Project 23029 – The Landing 3.0  
New Construction – 555 S. Harrison St. Fort Wayne IN, 46802

## **ADDENDUM No.2**

October 4, 2024

**Addendum #2**

DRAWING CONTENTS  
**STAIR SECTIONS**

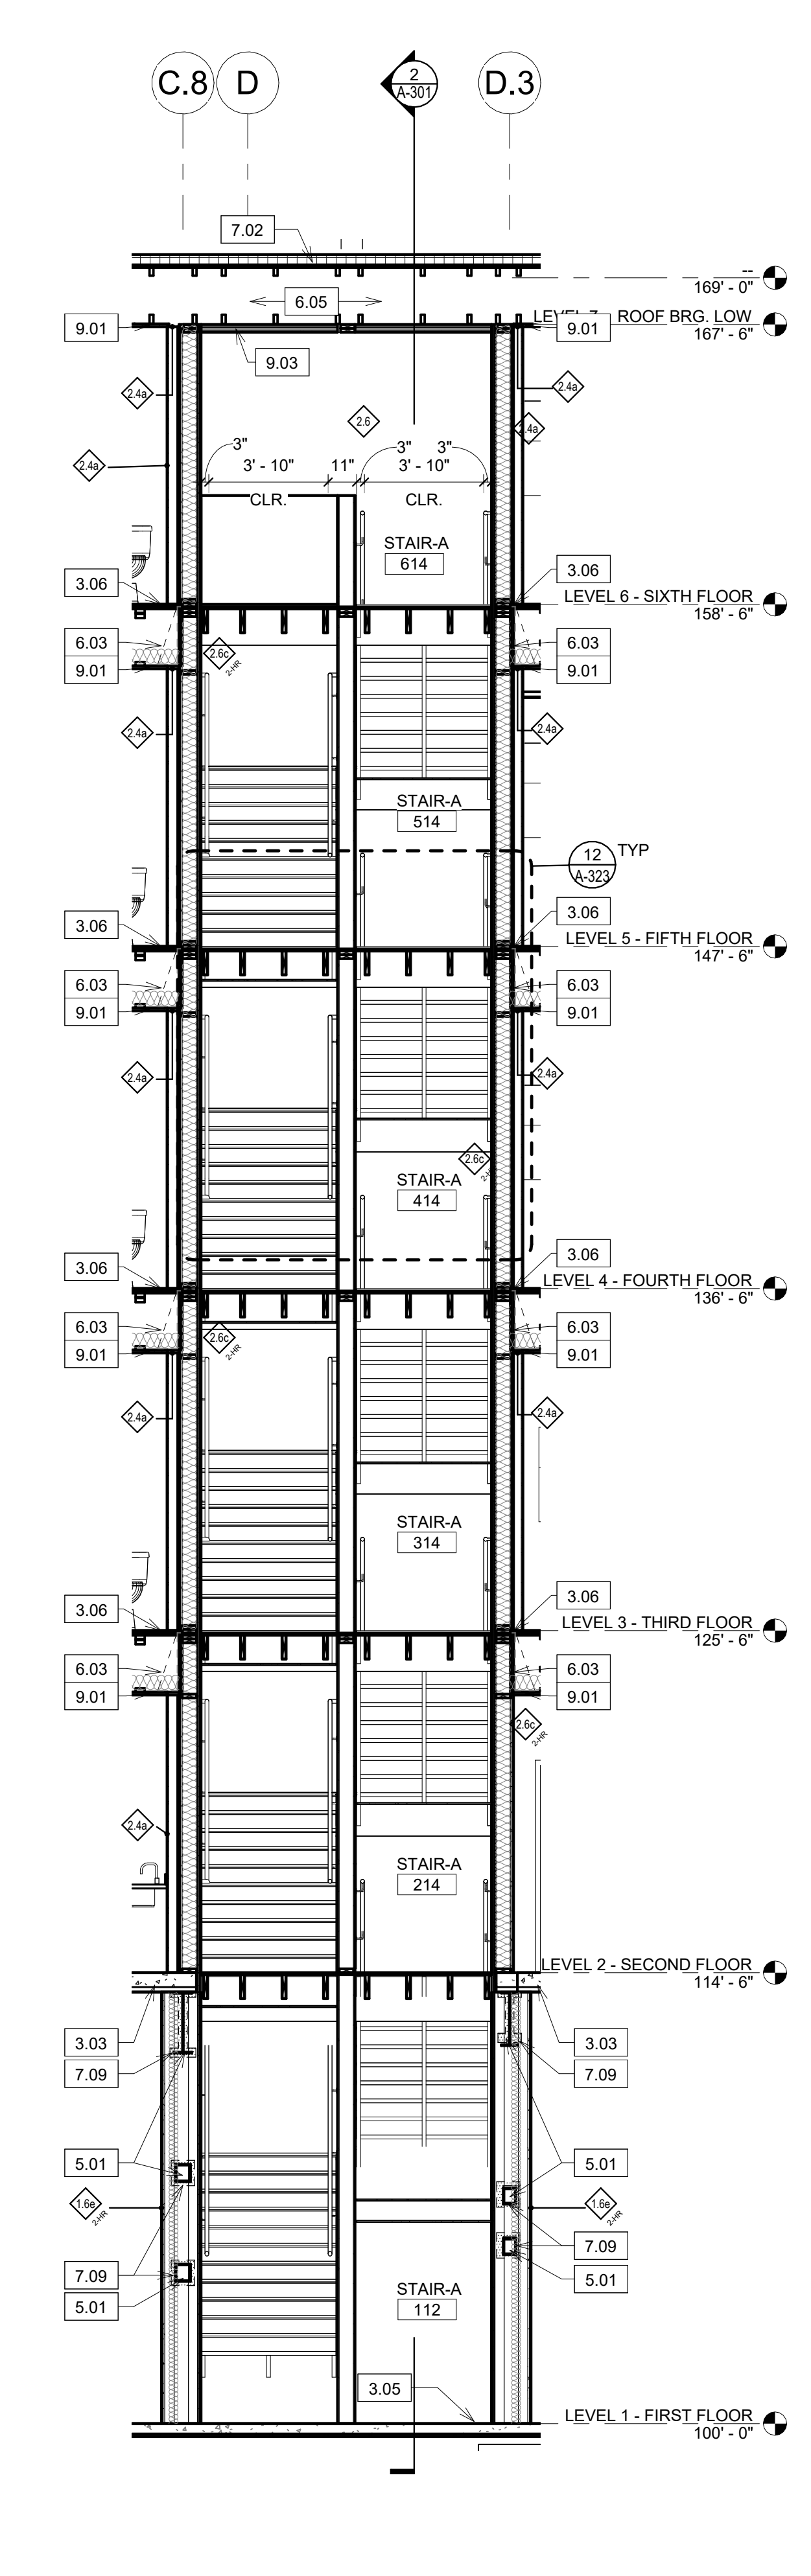
1. Sheet A-010 – Interior Wall Type Legend
  - a. Clarification: See attached revised sheet with the revisions to wall type 1.4a & 1.6a wall type.
2. Sheet A-322 – STAIR SECTIONS
  - a. Clarification: See attached revised sheet with the revisions to detail #12 showing stair handrails as field painted steel pipe handrails in lieu of stained wood handrails.
3. See attached Civil Addendum #2.
